LATHAN
ARCHITECTS
LATHAN ■ BRYANT ■ CALMA

ADDENDUM NO. 2
ADDITION AND RENOVATION FOR FLOMATON ELEMENTARY SCHOOL
PACKAGE A: MEDIA CENTER AND CLASSROOM ADDITION
DCM NO. 2021011 PSCA NO. 9167
Architect Job No. 21-04A
March 29, 2022

The Plans and Specifications are hereby amended. The following supersedes all contrary and/or conflicting information and is made part of the contract documents.

E4.1

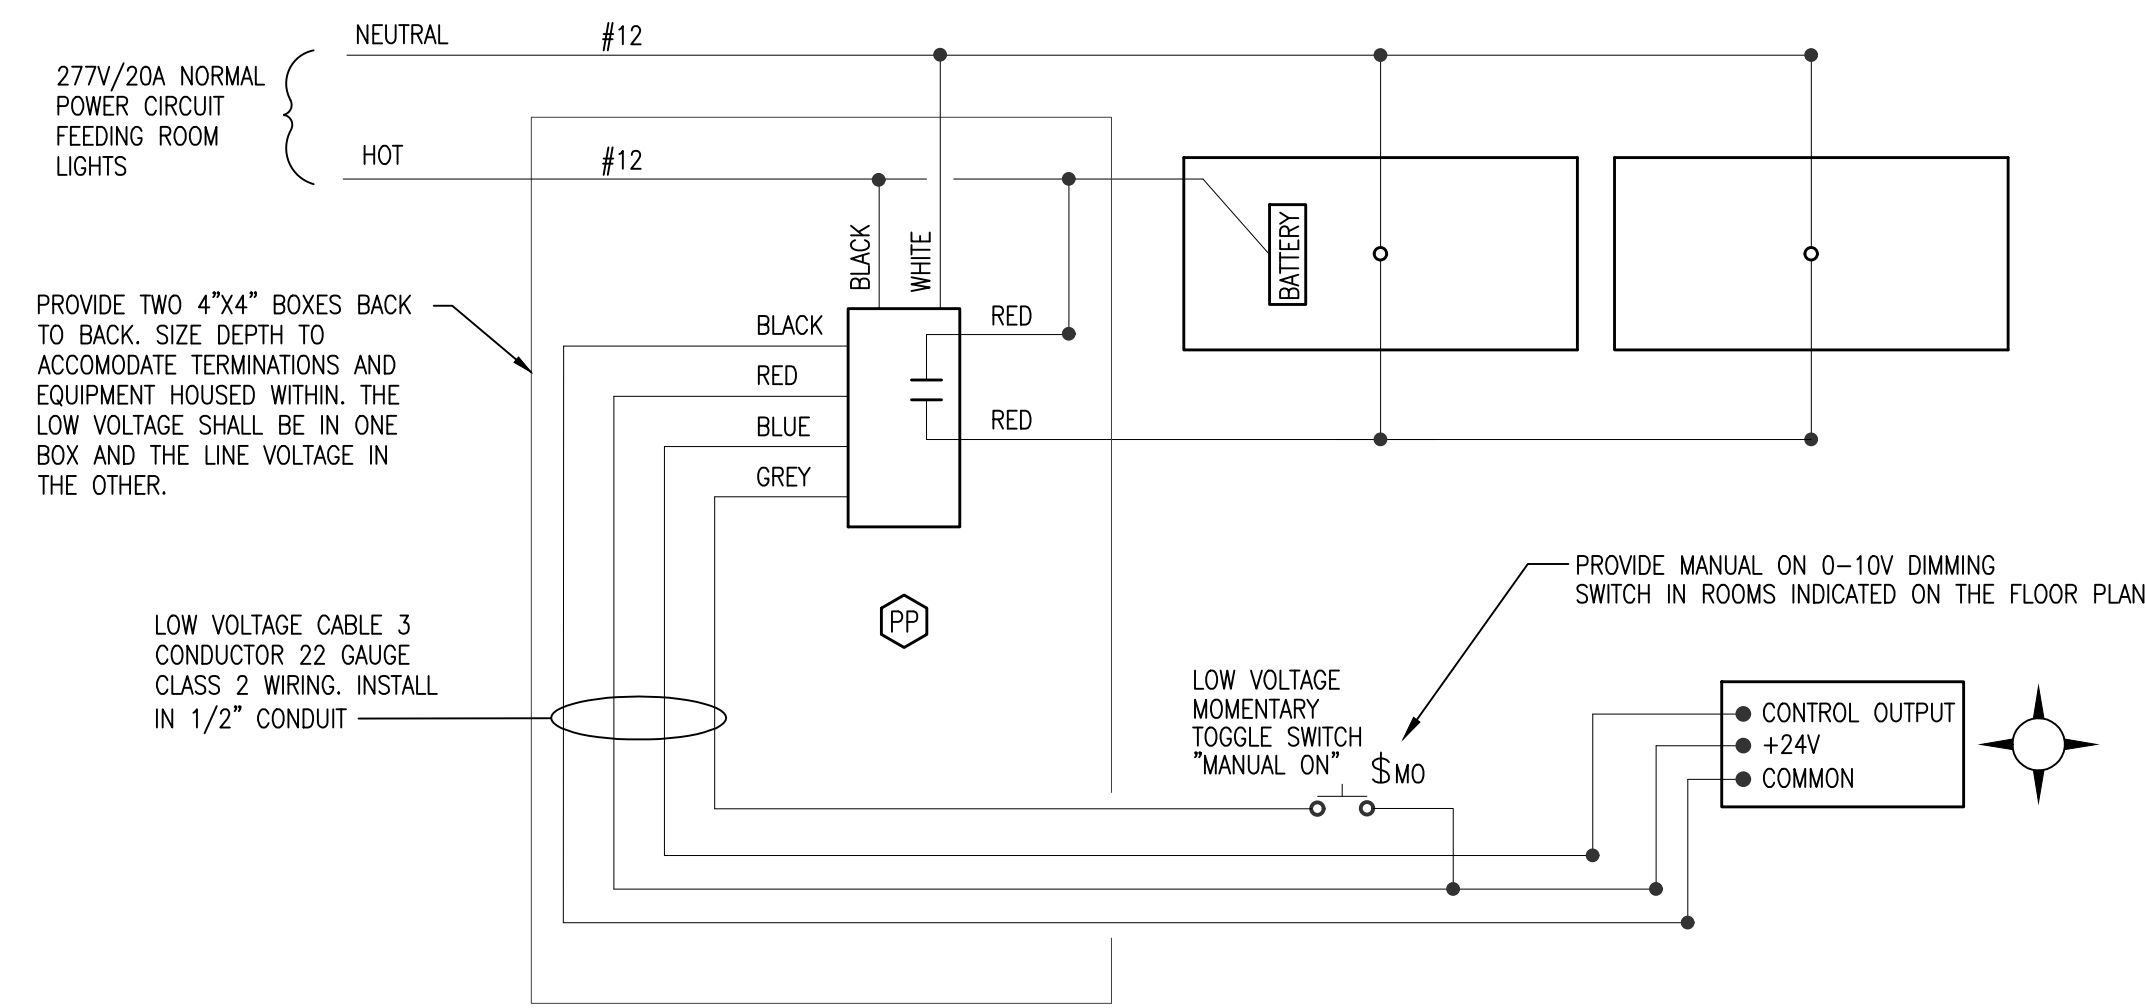
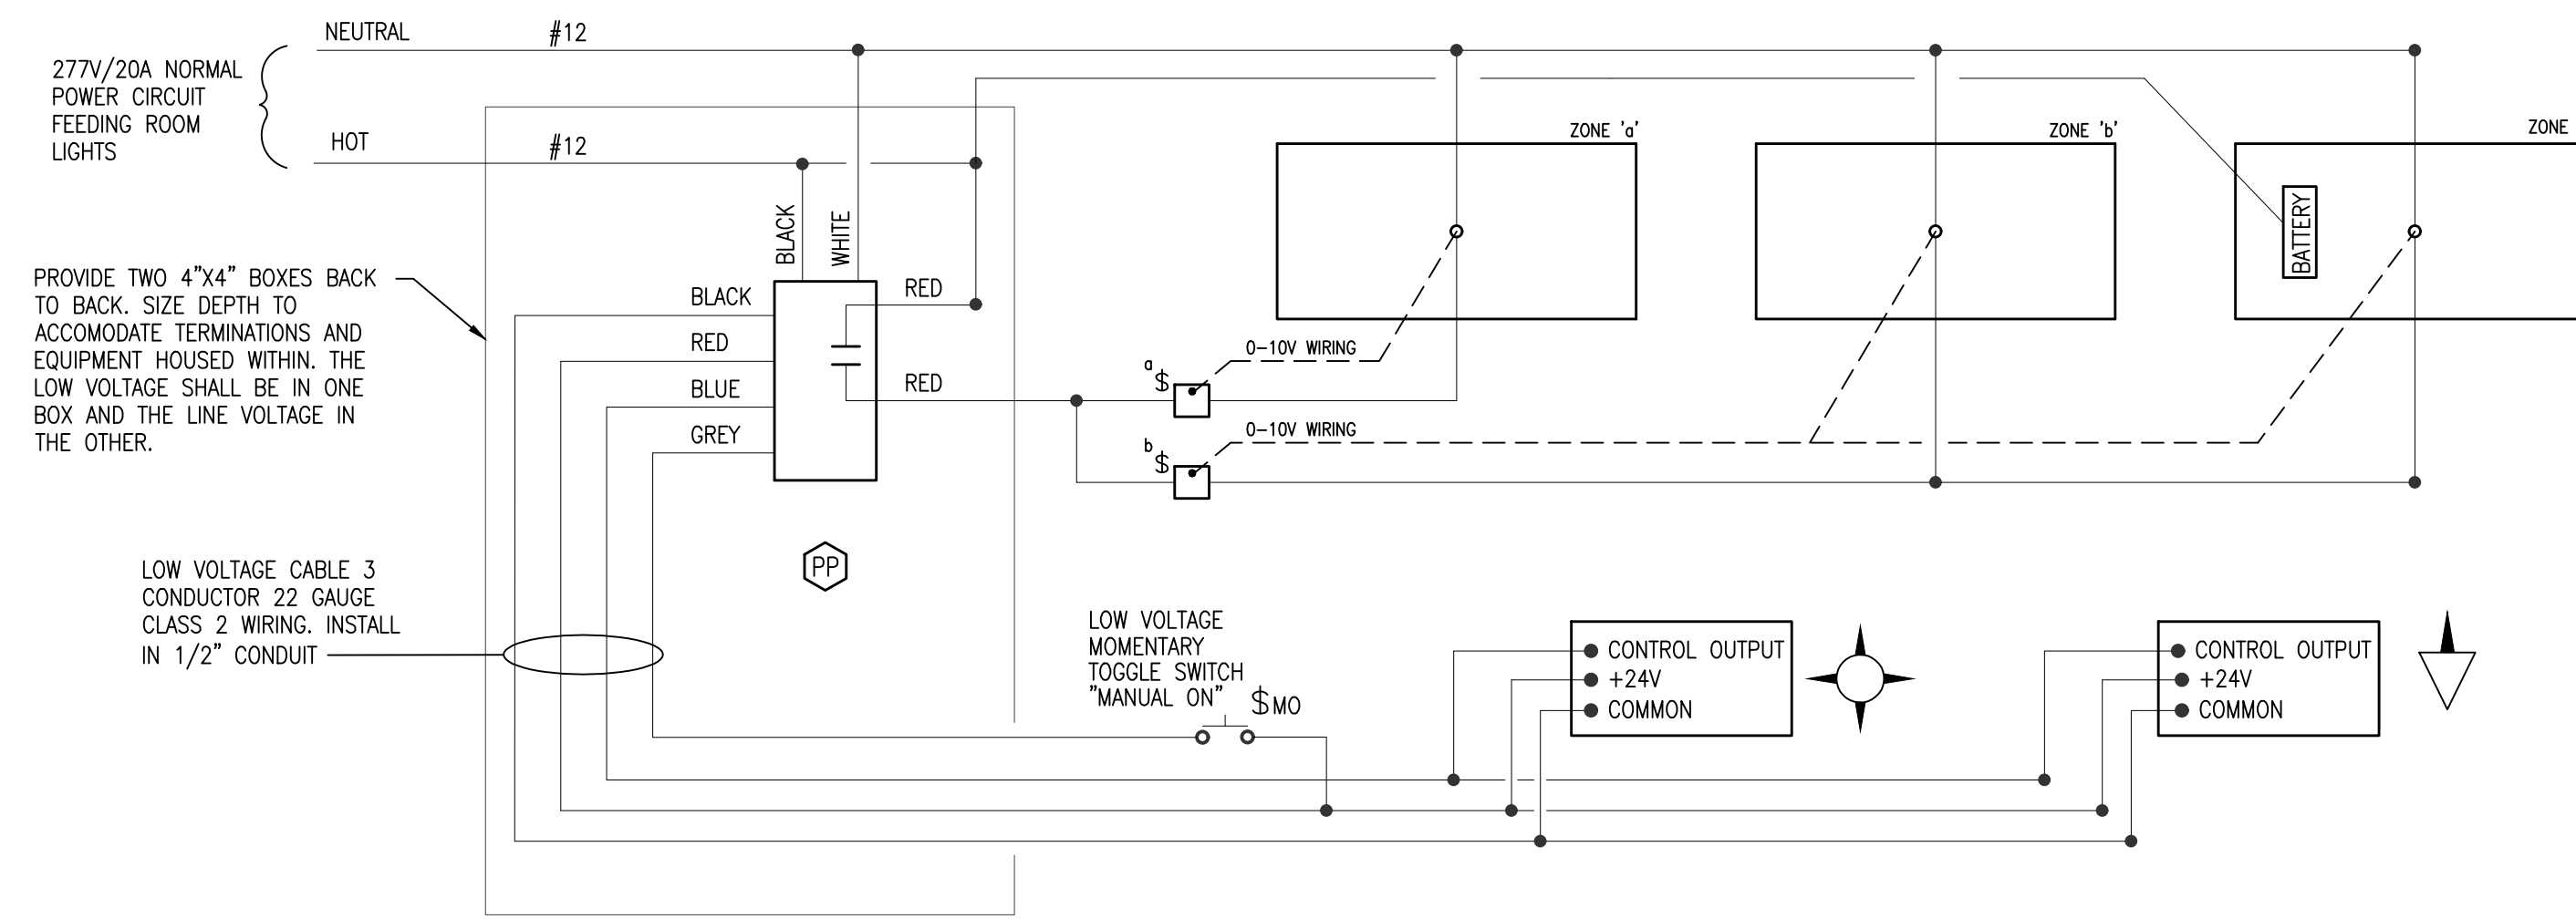
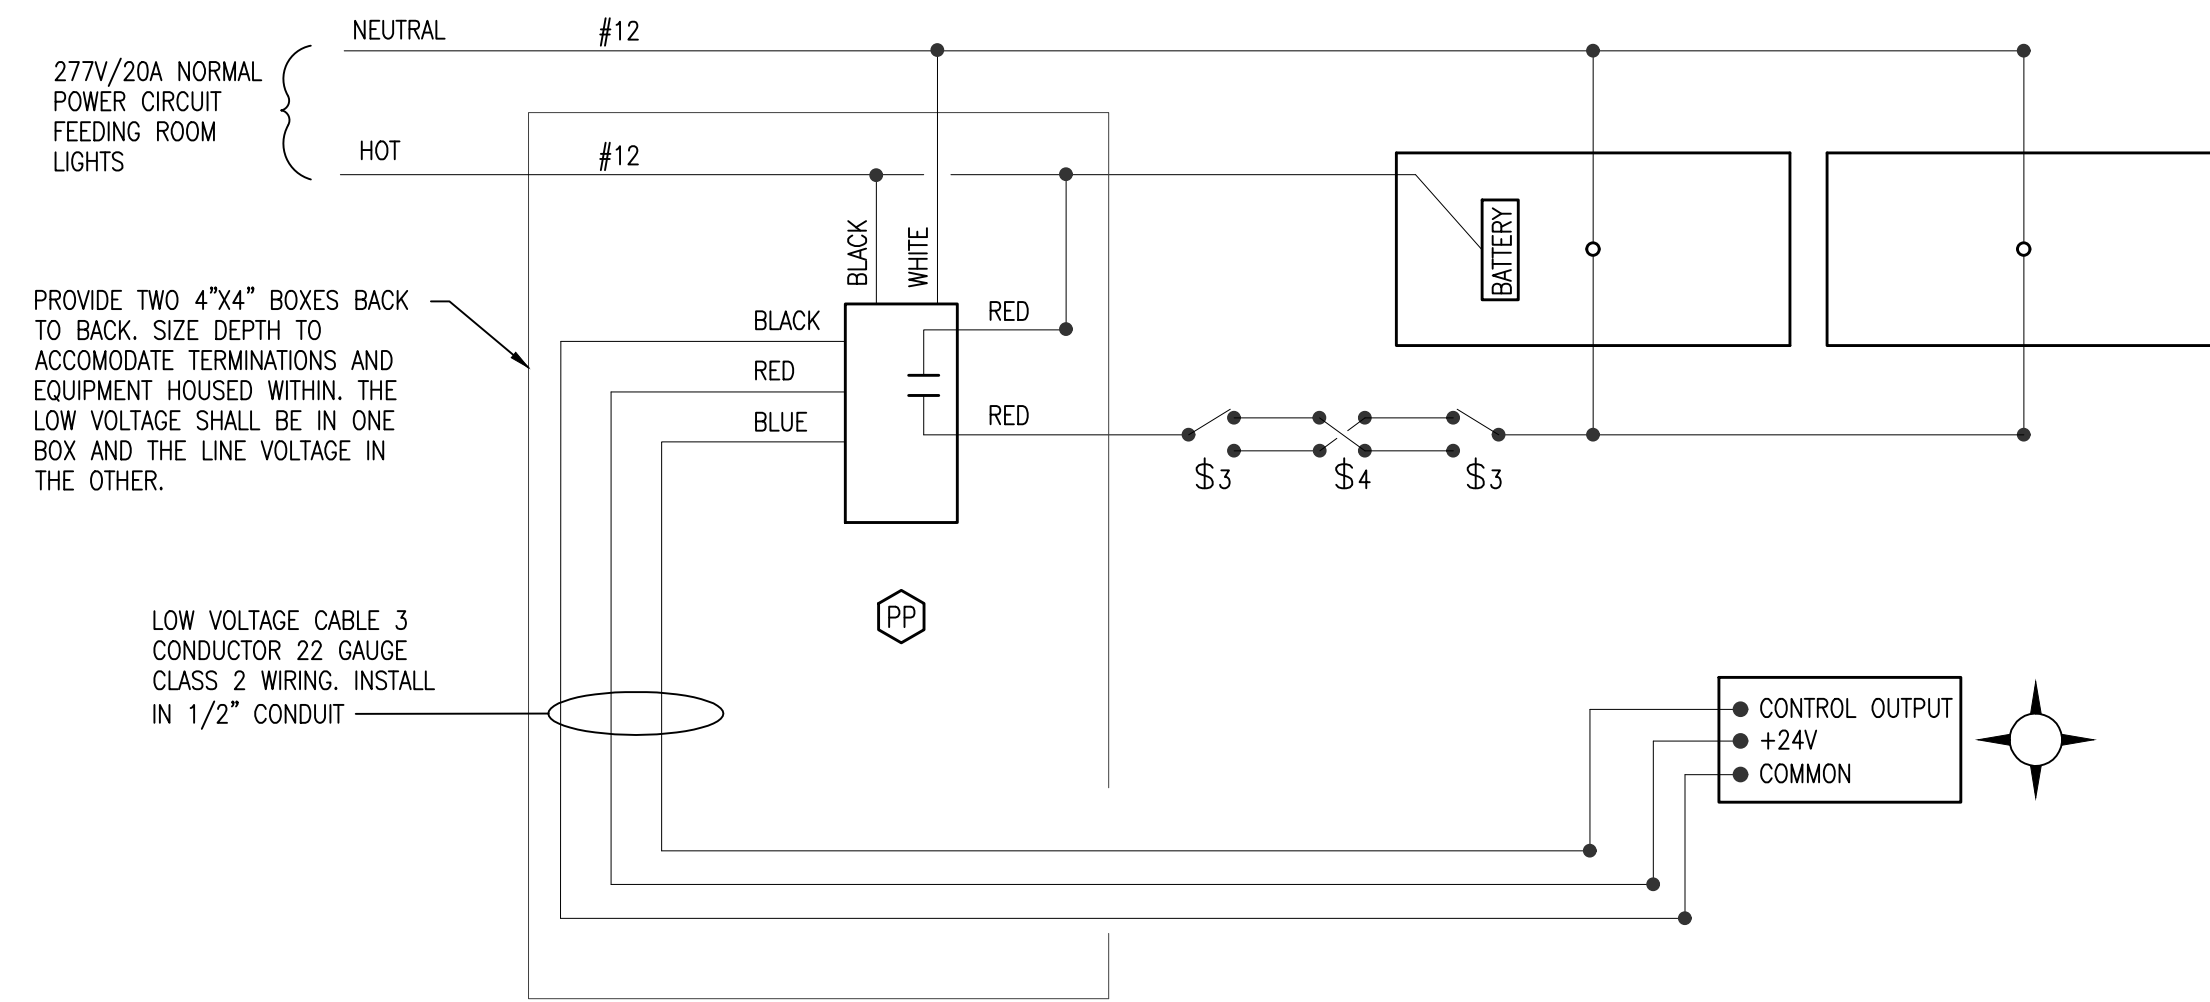
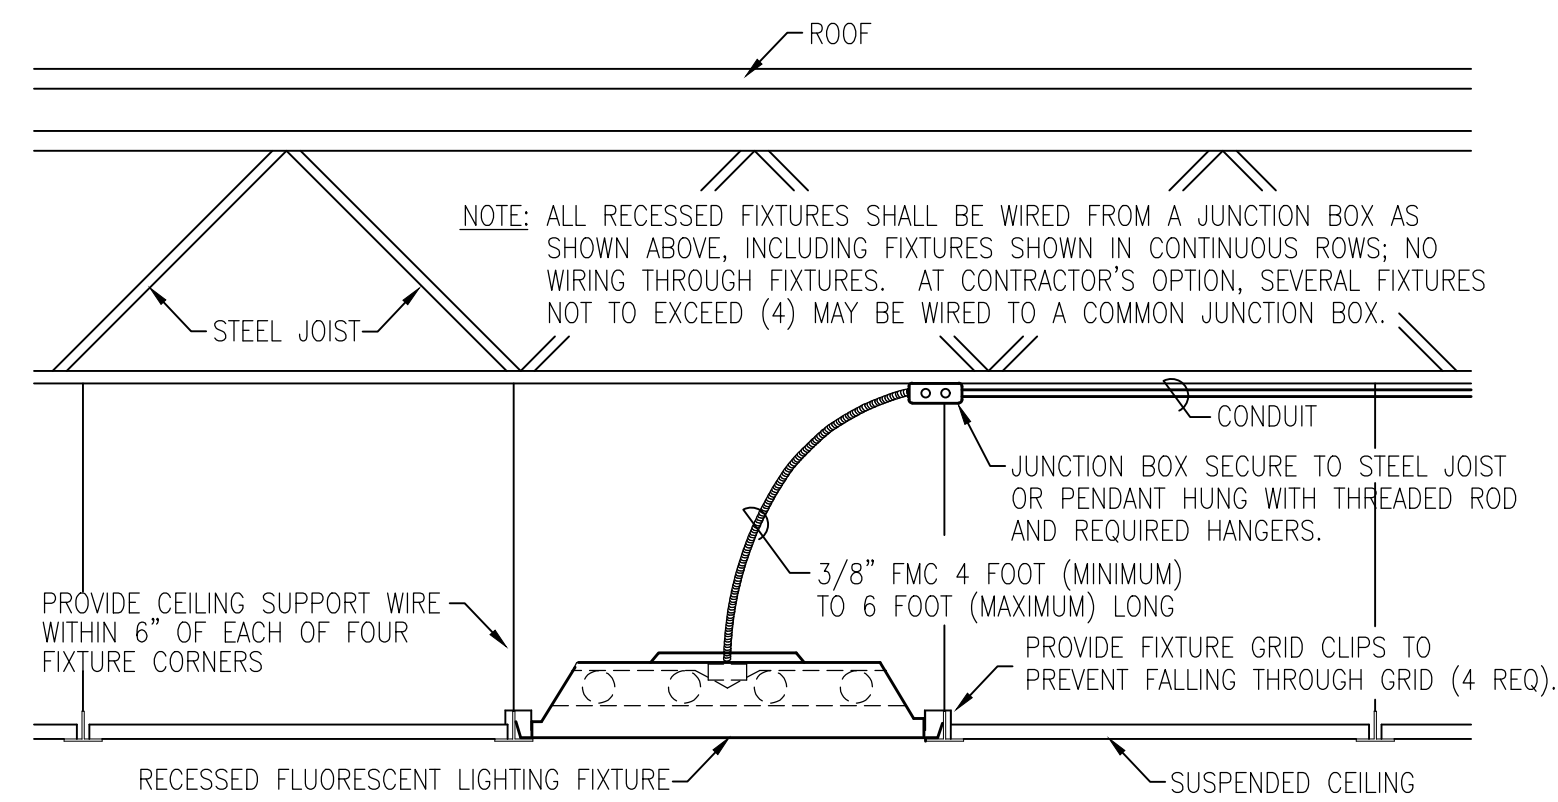
7. E4.1 – Electrical Details – see revised sheet.
8. E4.2 - Electrical Details – see revised sheet.
